Technical Service Information

KIA F4E-III

ERRONEOUS GEAR RATIO DTC's

Figure 1

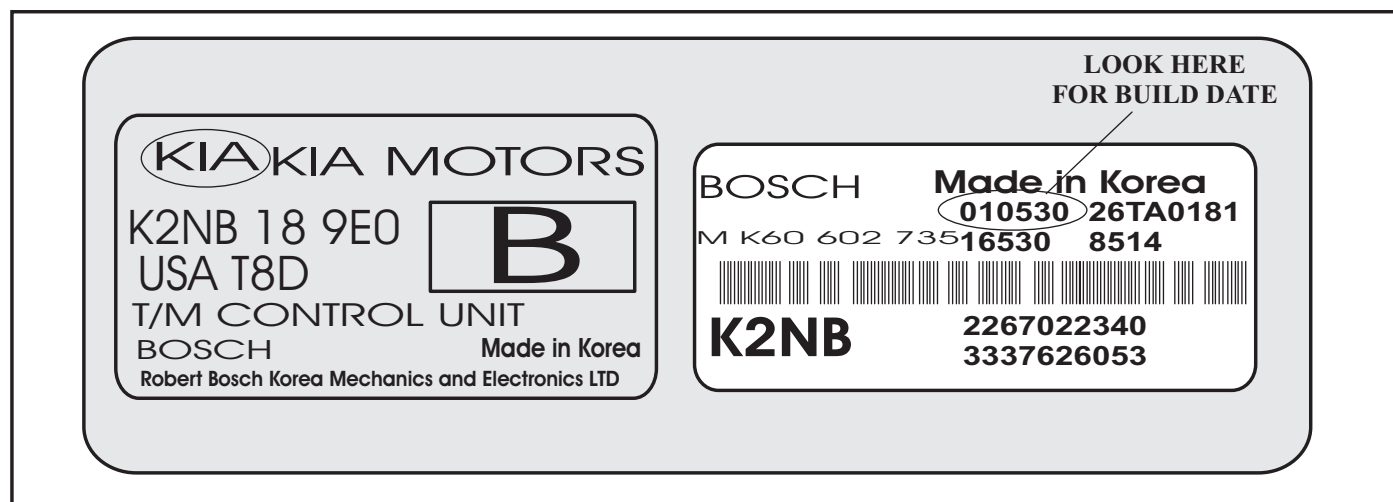
CORRECTION: The TCM did not receive a part number change when this new TCM logic was implemented. Check the production date of the vehicle. If October 18, 2000 or later is the production date of the vehicle, the updated TCM should be in the vehicle. It is possible that the TCM may have been previously exchanged with an earlier version. If there is any doubt, locate and remove the TCM under the dash and to the left of the steering column. On the TCM is a white label with the word Bosch written in the upper left corner (See Figure 1). To the right it says "Made in Korea." Underneath those words is a 6 digit number which provides the build date. The year, then the month and then the day is displayed. The example in Figure 9 is May 30, 2001. October 18, 2000 would appear as 001018. Any TCM built before this date will need to be updated.

Figure 2

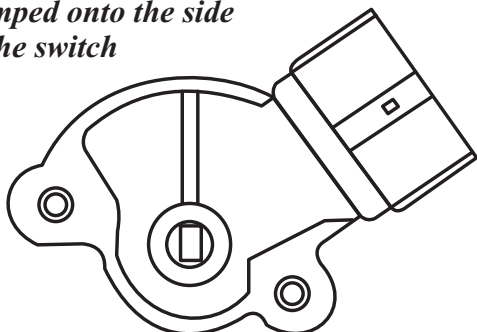
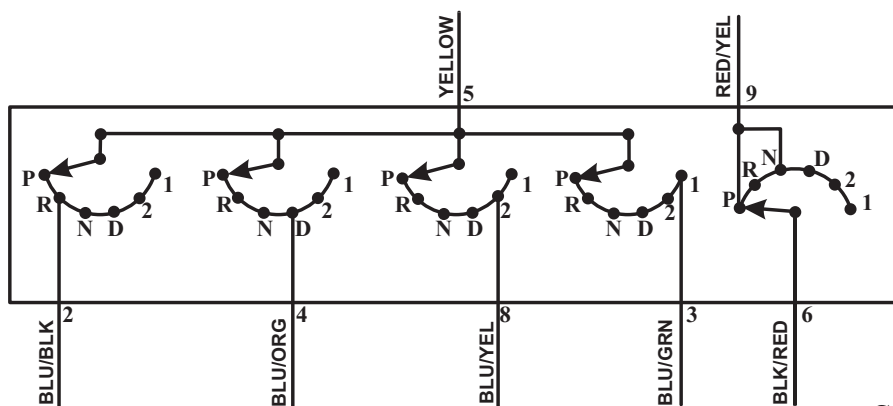
The Inhibitor Switch may also need to be replaced. It was updated November 22, 2001 and will have a stamping on the side of the switch with the same dating sequence as on the TCM, i.e.; 011122. If the Inhibitor Switch has an earlier date, replacement with a new switch is recommended. Figure 2 provides a continuity check chart for the Inhibitor Switch as well as an electrical wire diagram in the event further testing is required.

Check for build date stamped onto the side of the switch
